# SAFETY RECALL BULLETIN

**AUTOCAR SAFETY RECALL A-1003**  
NHTSA Recall 10V-363

Ignition Relay Replacement

Autocar has identified a defect in ignition relay for 2008 and 2009 model-year ACX model heavy-duty class 8 vehicles. Water intrusion in the ignition relay of the affected vehicles may lead to corrosion, which may short-circuit the relay causing the part to fail. Failure of the relay could cause the engine to shut down without warning or fail to start.

**Figure 1**

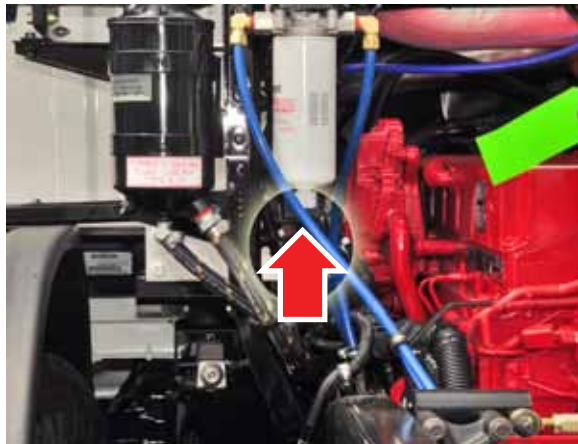
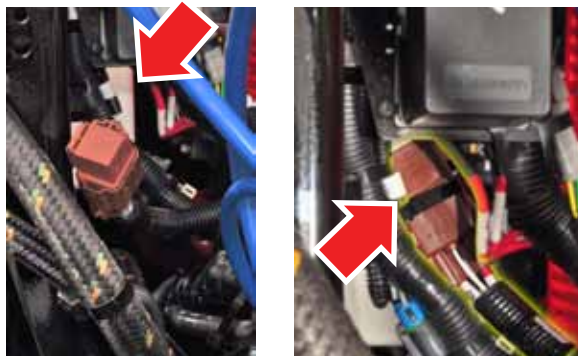
2. Locate the ignition relay switch (brown) near the external fuse box (see *Figure 1* and *Figure 2*).

**Figure 3**

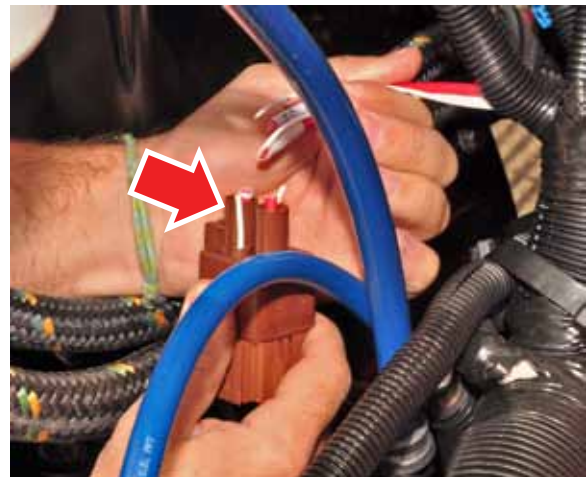
3. Peel back the wire loom to expose the wiring. Using diagonal cutting pliers, cut the four wires as close as possible to the existing ignition relay connector. Discard the relay and connector (see *Figure 3*).

**Figure 4**

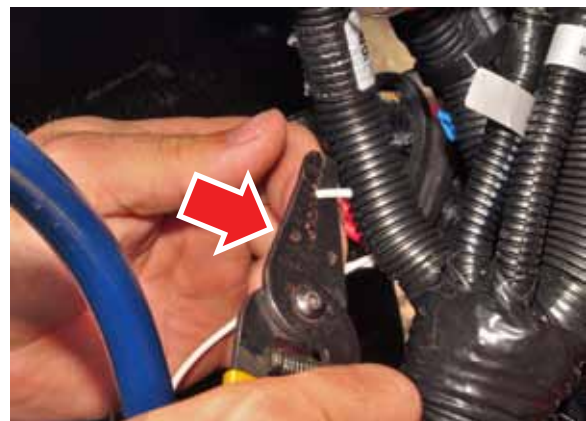
4. Using wire stripping pliers, strip away 1/4" (6.35 mm) of insulation from the four existing wires (see *Figure 4*).

**Figure 5**

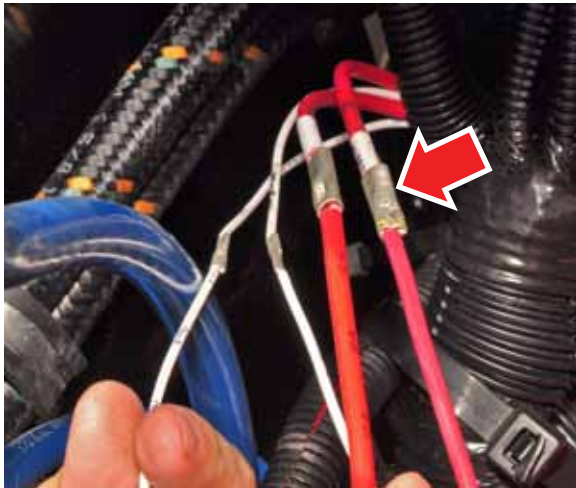
5. Match the existing wire numbers to the corresponding wire numbers contained in the service kit.
6. Using wire crimper pliers, crimp the new wires to the existing wires. Using an electric heat gun, heat shrink the connections (see *Figure 5*).

**Figure 8**

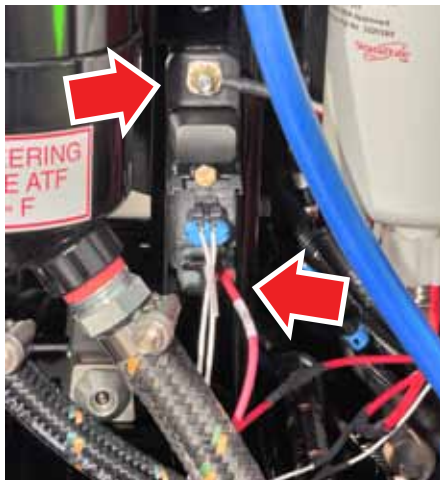
9. Install two electrical connectors into the relay (see *Figure 8*).
10. Using a 1/2" socket and torque wrench, attach the ring terminated wire (1 C-A) to the 5/16" threaded stud and tighten to 9 Ft-Lbs (40 N-m) of torque (see *Figure 8*).

**Figure 9**

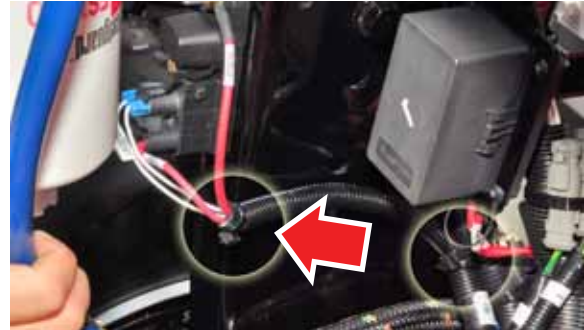
11. Reinstall wire loom and secure as required (see *Figure 9*).
